HISTORIC PRESERVATION BOARD STAFF REPORT

160 Marine Way

Meeting	File No.	Application Type
August 5, 2026	HP-417-2026	Certificate of Appropriateness & Waiver

The item before the Board for consideration of a Certificate of Appropriateness (HP-417-2026) and Waiver in association with exterior modifications to an existing contributing structure and a 3rd story addition to the existing, contributing, single-family residence, located at **160 Marine Way, Marina Historic District**.

2
A3.02
PROPOSED NORTH ELEVATION
SCALE : 1/4" = 1'-0"

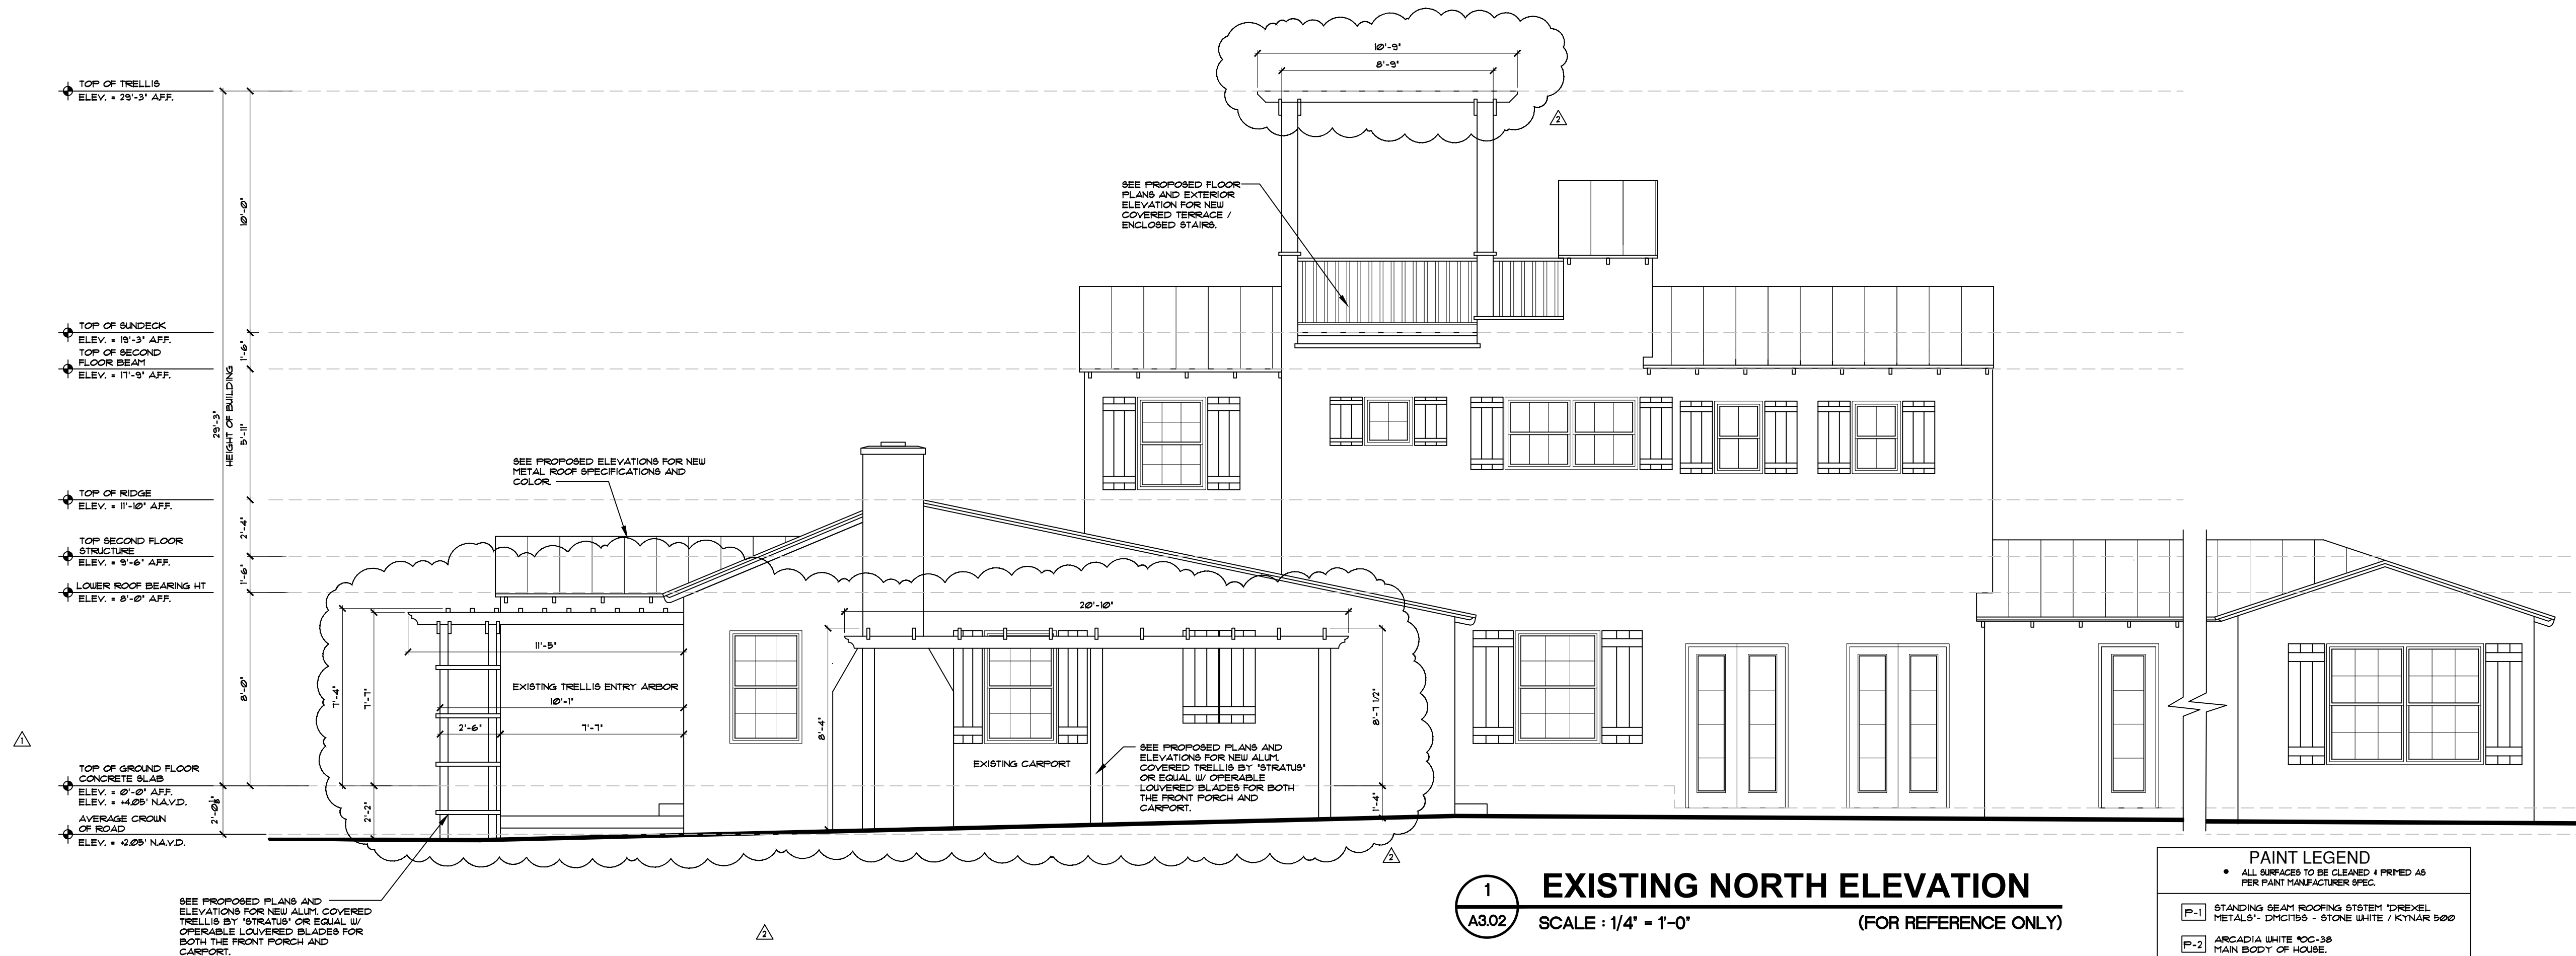
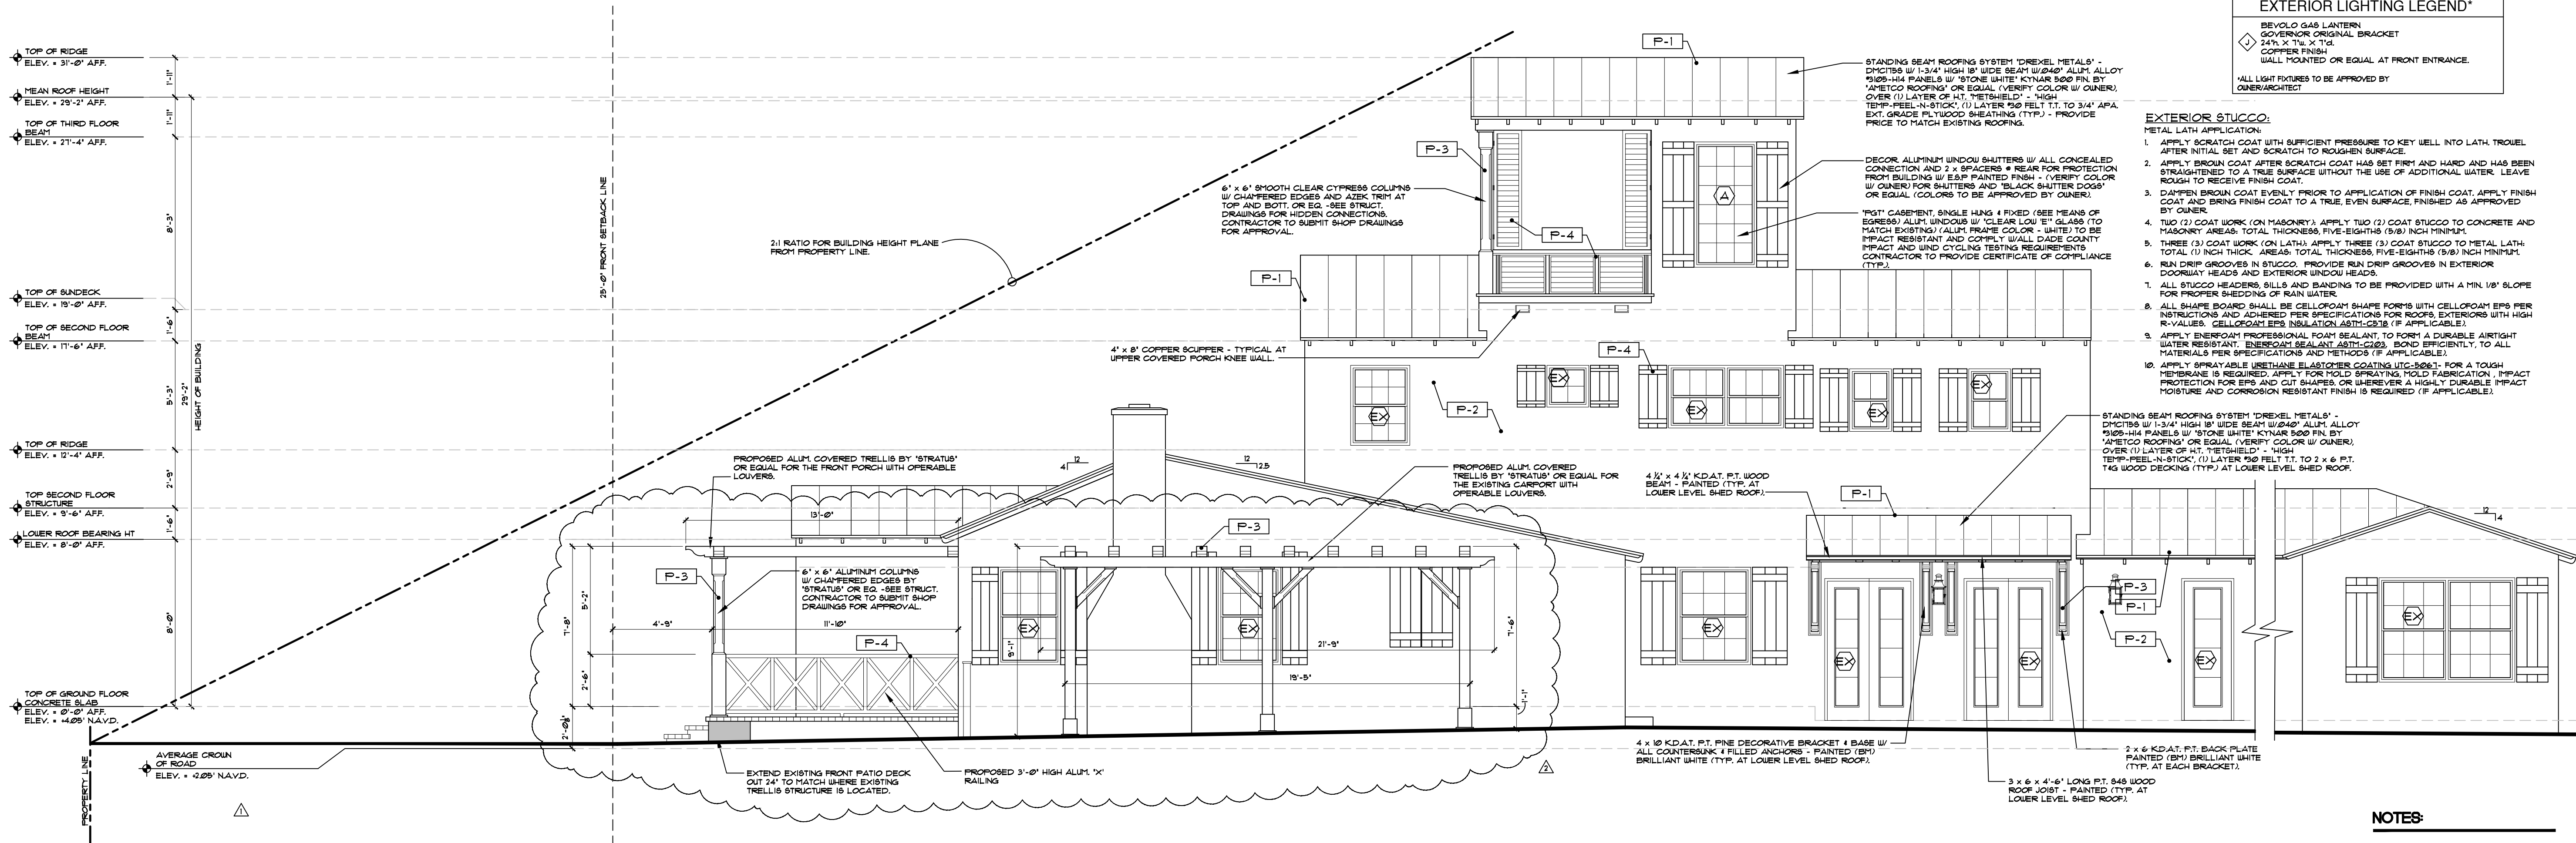
A gravel driveway (single vehicle width) flanked by one row of paver bricks exists on the north side of the property. An existing trellis carport is located adjacent to the contributing structure and behind the front wall plane of the home. A previously noted, the existing wood trellis is proposed to be replaced with an aluminum trellis.

For **Architectural Style**, there are concerns with regards to the introduction of the aluminum louvered front wall and covered porch windows as these distinctive elements were not originally used on the structure. As noted in the Delray Beach Historic Preservation Guidelines (as shown below), the existing historic structure was built in the 1940s in the Minimal Traditional style. This architectural style was inspired by 1920s and 1930s Tudor style cottages that were typically one-story, were very symmetrical in plan shape, and had simplified elements and materials. The introduction of the louvered elements on the proposed third floor and front wall designs are not compatible with the existing architectural style and gives the structure a more modernize appearance. The board will need to make a determination that the proposal is compliant with the **Architectural Style** visual compatibility standard.
